S.I.L. NO. 04-560-04

SERVICE INFORMATION LETTER

SUBJECT: Large Oil Cooler Plenum and NACA Duct Modification

Figure 1. NACA Duct Trimmed for Large Outlet

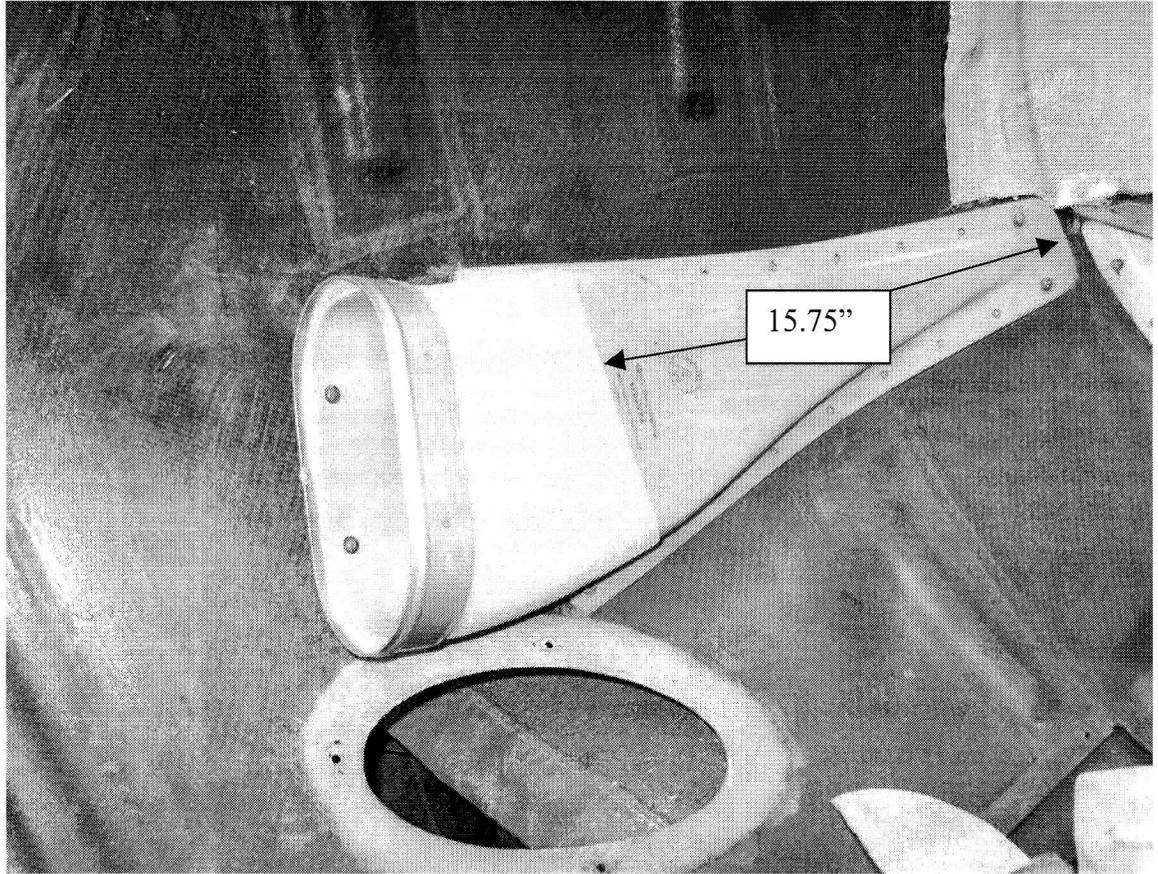
6. Trim off the portion of the old NACA duct determined using the trim template (Figure 1).
7. Slide the new replacement NACA duct outlet onto the original NACA duct (Figure 2). The portion of the old NACA duct closest to the cowling may have to be trimmed more. With the replacement NACA duct outlet in place, the distance from the forward portion of the replacement duct to the forward end of the old NACA duct should be 15.75 inches (Figure 2).
